**GOVERNMENT OF THE DISTRICT OF COLUMBIA
DEPARTMENT OF TRANSPORTATION**

MEMORANDUM

SUBJECT: **BZA Case No. 19377** – 3015 4th Street NE (St. Paul the Apostle Townhomes)

Figure 1 - Site Plan (Source: Vika, Applicant's Prehearing Submission, dated February 28, 2018)

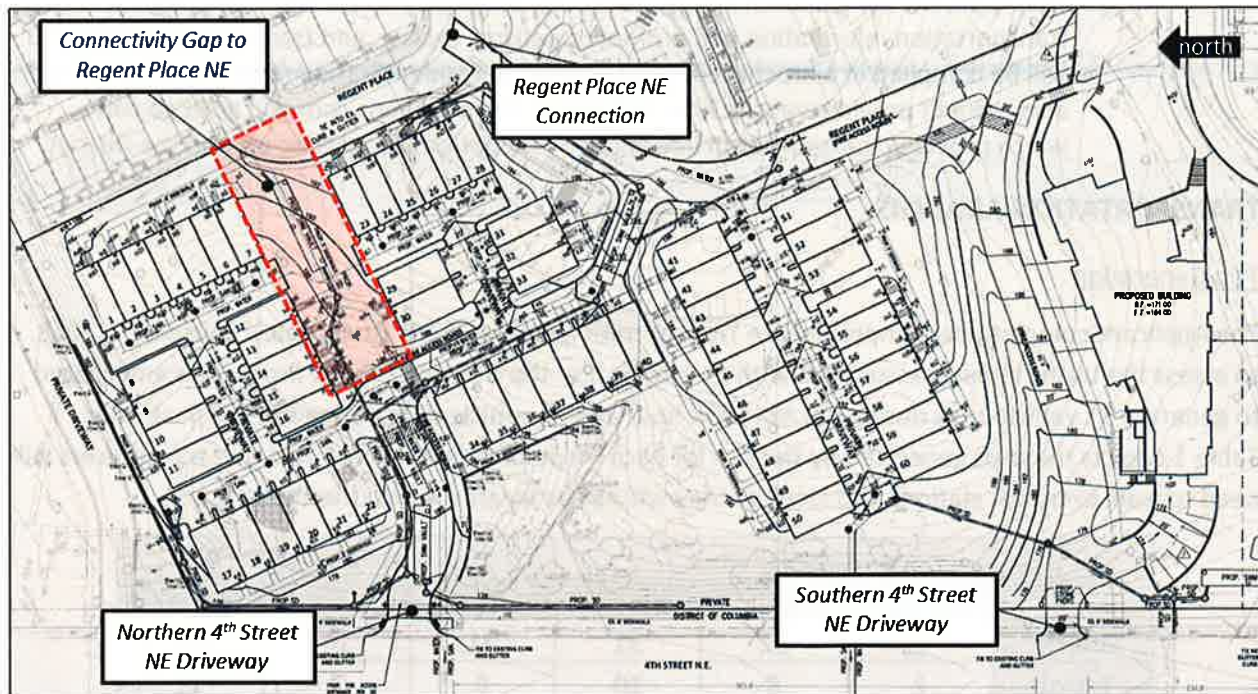
- Provide a 6-foot pedestrian connection and associated public access easement no less than 42 feet wide extending north from the intersection of the northern driveway and private road to the property line at the eastern curve of Regent Place, as approximated in the red box in Figure 1;

DDOT supports maximizing site porosity to improve the dispersion of traffic and enhance the connectivity of all modes on both public and private streets. The subject property is located in an area with limited east-west connectivity between 4th Street NE and 7th Street NE. As shown in Figure 1, the Applicant has not proposed to connect the northern driveway through to Regent Place but has left the area clear for a future connection. DDOT considers this missing connection to be a missed opportunity, particularly as the connecting driveway is designed to function like a street. To improve connectivity and maintain the space in perpetuity, DDOT recommends that the Applicant provide a pedestrian connection no less than 6-feet wide at this location with an associated public access easement no less than 42 feet in width. DDOT also recommends that the Applicant should provide public access easements for each of the proposed private streets and their associated sidewalks. The requested easements increase the future potential to improve access between 4th Street NE and 7th Street NE for the general public.

DDOT notes that all of the sidewalks shown on the plan adjacent to private streets are five (5) feet wide. DDOT requires a minimum unobstructed width of six (6) feet for all public streets. While the streets are private, DDOT recommends expanding the five (5) foot sidewalks by a foot to meet the minimum standards of a public street.

- Design all private streets to DDOT's 2017 DEM standards where they connect with the public street network;
- Provide 6-foot wide sidewalks adjacent to all private streets, including the driveway extending from 4th Street NE to Regent Place NE; with adequate landscape strips and/or pedestrian buffers, subject to DDOT's approval;
- Provide public access easements spanning the extent of all private streets and associated sidewalks;

Figure 2 – Landscape Plan (Source: Studio 39, Applicant's Prehearing Submission, dated February 28, 2018)

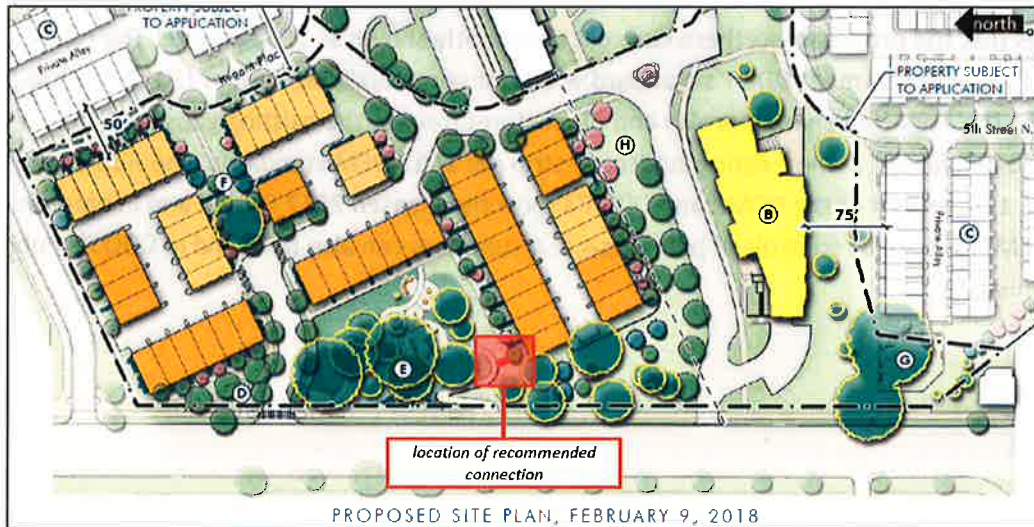
- Improve pedestrian porosity between the site’s access points by implementing a sidewalk connection from the 4th Street NE sidewalk to the pedestrian switchback ramp within the “Sylvan Grove” concept, as shown on the Applicant’s landscape plan associated with the prehearing submission (sheet B-3), titled “Proposed Site Plan, February 9, 2018.” Should the Applicant not pursue the “Slyvan Grove,” an alternative pedestrian connection between the two (2) proposed site access points may be acceptable, subject to DDOT’s review and approval.

To improve site porosity and encourage pedestrian travel, DDOT recommends the Applicant provide a sidewalk connection between the site's two access points on 4th Street NE that feeds into the private street network. The Applicant's prehearing submission proposes a landscape concept, shown in Figure 2, which could potentially facilitate this connection. DDOT recommends linking the proposed switchback sidewalk in the conceptually proposed preserve to the sidewalk adjacent to the proximate units. If the connection is not feasible due to the constraints related to existing trees, DDOT may accept an alternative pedestrian connection between the two (2) proposed driveway entrances.
